City of Richmond

Report to Committee

To: Planning Committee **Date:** April 26, 2011
From: Brian J. Jackson, MCIP **File:** RZ 10-554759
Director of Development
Re: **AM-PRI CONSTRUCTION LTD. has applied to the City of Richmond for permission to rezone 9791 & 9811 Ferndale Road and 6071, 6091 & 6131 No. 4 Road from "Single detached (RS1/F)" to "Medium Density Townhouses (RTM2)" in order to develop a 24 unit townhouse development.**

APPENDIX 1

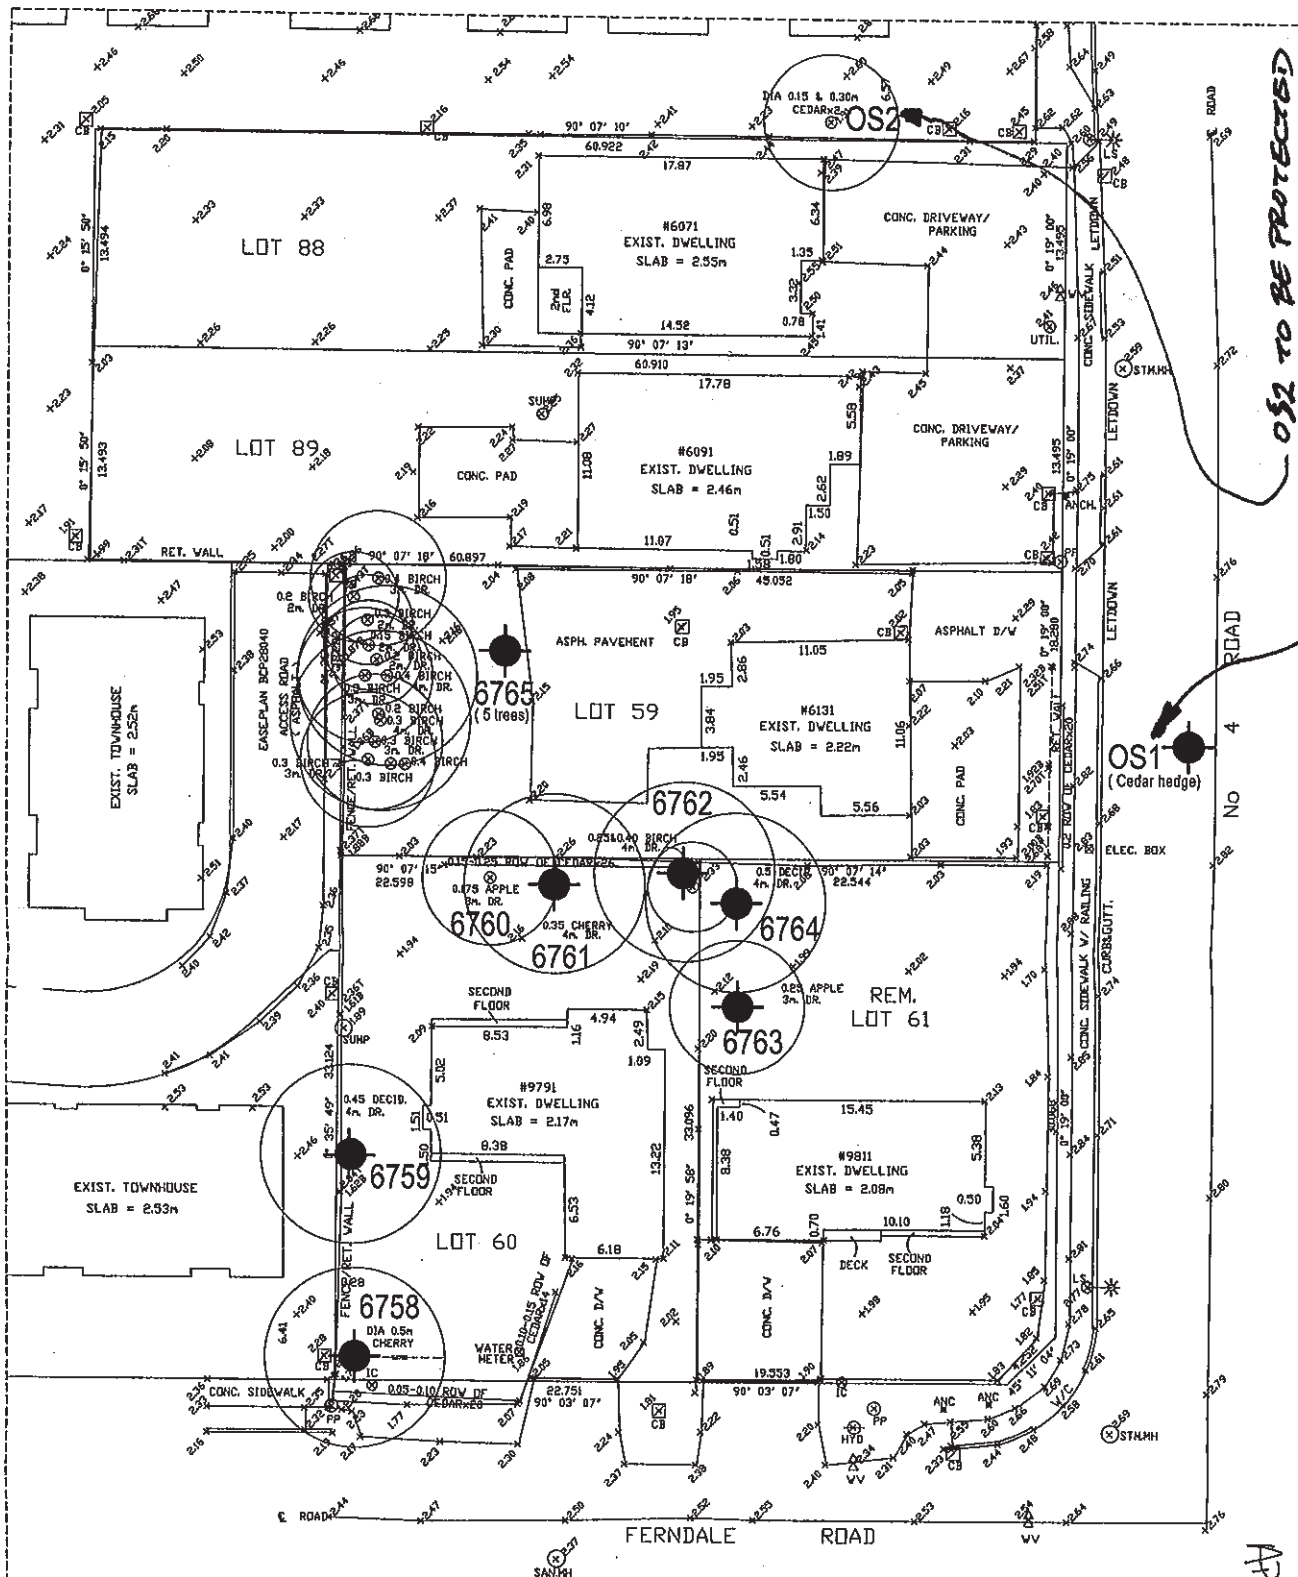
An Arborist Report and site survey (**Attachment 5**) was submitted to assess the existing trees on the site for possible retention of existing trees. The submitted report indicated that of the 18 trees currently on the subject site, none were identified as good candidates for retention. One neighbouring tree to the north is to be protected during the construction period.

A detailed site review was conducted by City staff which confirmed with the report that of the 18 trees on-site, 15 are in poor condition and will need to be removed. Of the remaining three (3) that are listed in moderate health, all are located within the buildable area of the site and will need to be removed. In addition, the re-grading of the site to meet the required flood plain regulations would result in additional fill which would make any possible survival of these trees very unlikely.

Of the 18 trees that are to be removed, all 18 would need to be replaced in accordance with the 2 for 1 replacement policy. A review of the new tree plantings will be conducted at the Development Permit stage where it is anticipated that the site should easily be able to accommodate this number of trees.
